Town of Gorham Planning Board Meeting April 4, 2022

Item 4 - Pre – Conceptual Design Review Discussion – Grondin Corporation/Mountain Trail Meadows – Subdivision Review – a request for sketch/pre-application review for a cluster subdivision on approximately 103 acre parcel located off Wescott Road. The lot is zoned Rural (R). The lot is shown on Map 87, Lot 28-1 and 30. The property is currently a field, wetland, and forest. The applicant is Ken Grondin of the Grondin Corporation. The current property owners are Thomas Smilie and RWS Associates. The applicant is represented by Jayson Haskell, P.E. of DM Roma Consulting Engineers.

The applicant is proposing a cluster subdivision for the Board’s review.

Google earth image taken in May, 2018.

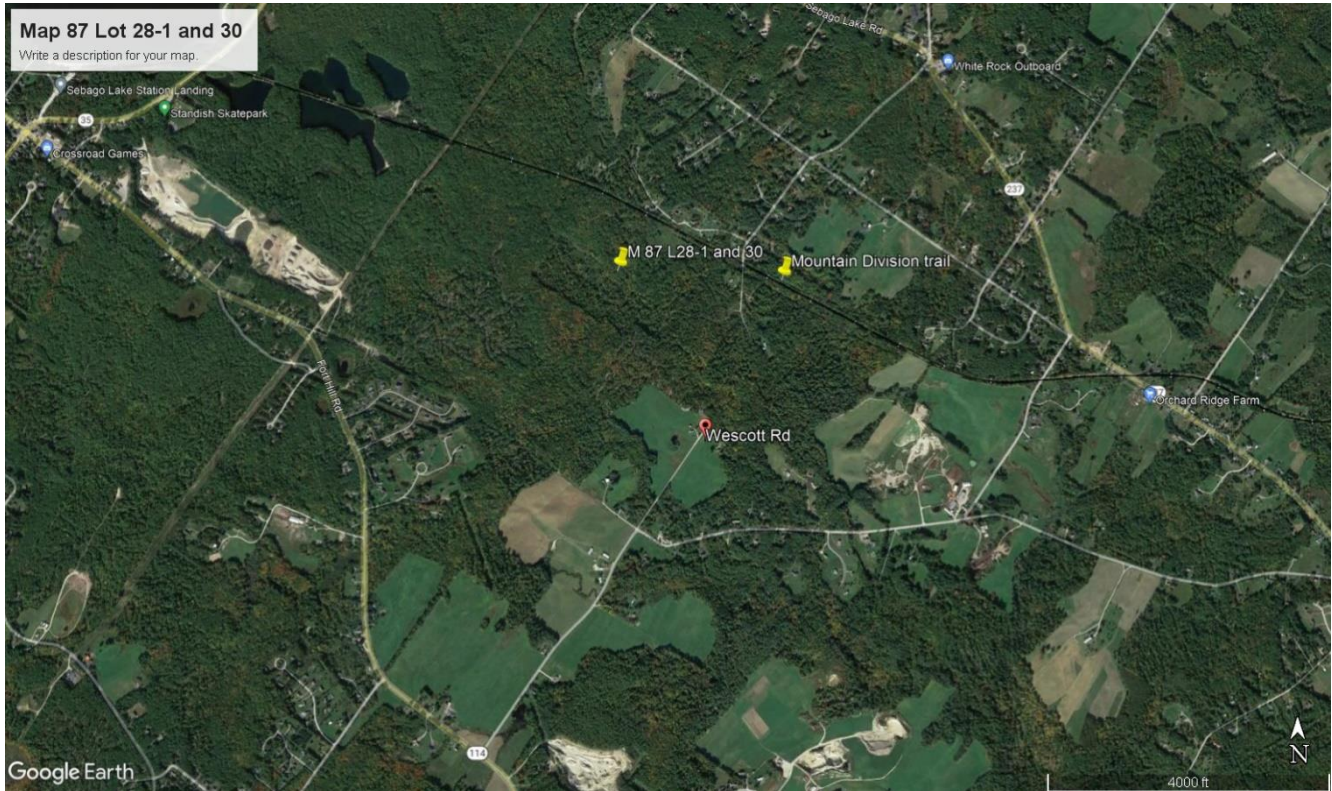
- Zoning – Rural/Shoreland overlay
- Possible trail connections and all possible amenities should be shown on the plan.
- The parcel contains wetland, and floodplain.
- Water main runs through parcel.
- The Conceptual Plan needs to include significant habitat corridors, rare or endangered habitat, roads and buildings within 100 feet of the property, indication of overall stormwater flow direction, species and size of existing trees, historic and cultural resources such as existing barns, trails, cellar holes, stone walls, and other noteworthy features unique to the property.
- The landscape architect should submit the details for the conceptual plan.

- The applicant should provide more information to address the outstanding resource items required.

- The applicant should provide a percentage calculation of the estimate of open space currently proposed.
